Re: Corrective Action completed.

RE: Uwharrie Family Care Home – FC Biennial Survey

STATEMENT OF DEFICIENCIES AND PLAN OF CORRECTION	(X1) PROVIDER/SUPPLIER/CLIA IDENTIFICATION NUMBER: FCL076037	(X2) MULTIPLE CONSTRUCTION A. BUILDING: 01 B. WING _____	(X3) DATE SURVEY COMPLETED 09/13/2023
--	--	---	---

UWHARRIE FAMILY CARE HOME

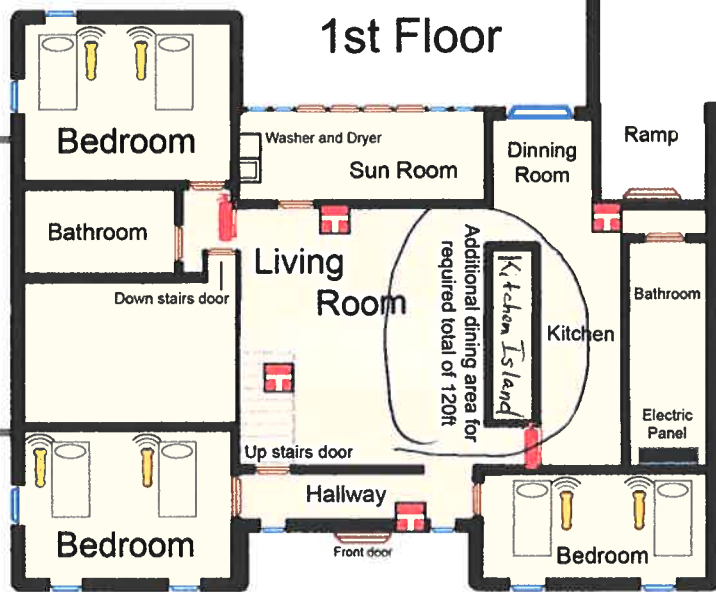
STATEMENT OF DEFICIENCIES AND PLAN OF CORRECTION		(X1) PROVIDER/SUPPLIER/CLIA IDENTIFICATION NUMBER: FCL076037	(X2) MULTIPLE CONSTRUCTION A. BUILDING: 01 B. WING _____	(X3) DATE SURVEY COMPLETED 09/13/2023
NAME OF PROVIDER OR SUPPLIER UWHARRIE FAMILY CARE HOME		STREET ADDRESS, CITY, STATE, ZIP CODE 4028 OLD NC HWY 49 ASHEBORO, NC 27203		
(X4) ID PREFIX TAG	SUMMARY STATEMENT OF DEFICIENCIES (EACH DEFICIENCY MUST BE PRECEDED BY FULL REGULATORY OR LSC IDENTIFYING INFORMATION)	ID PREFIX TAG	PROVIDER'S PLAN OF CORRECTION (EACH CORRECTIVE ACTION SHOULD BE CROSS-REFERENCED TO THE APPROPRIATE DEFICIENCY)	(X5) COMPLETE DATE
C 112	Continued From page 2 This Rule is not met as evidenced by: 1. At the time of the survey it was observed that the laundry room was located on the rear porch area and there were steps between the main level of the home and the rear porch. This is not compliant with the rule. Take the necessary steps to locate the laundry room on the same level as the living area of the house or build up the porch so it is level with the main living area.	C 112	<p>Washer & Dryer have been moved back to small bathroom as requested by inspection staff</p> <p>See floor plan where additional footage will allow for residents to dine and the 120 square feet requirements are met.</p>

C 123	Dining Room SECTION .0300 - THE BUILDING 10A NCAC 13G .0306 DINING ROOM (a) Family care homes licensed on or after April 1, 1984 shall have a dining room or area of at least 120 square feet. The dining room may be used for other activities during the day. (b) When the dining area is used in combination with a kitchen, an area five feet wide shall be allowed as work space in front of the kitchen work areas. The work space shall not be used as the dining area. (c) The dining room shall have operable windows and be lighted to provide 30 foot candles of light at floor level. This Rule is not met as evidenced by: 1. At the time of the survey it was observed that the area provided for the dining room was approximately 73 square feet instead of the required 120 square feet. This is not compliant with the rule. Take the necessary steps to provide additional space to meet the 120 square feet requirement for the dining room.	C 123

Fire Pull Station
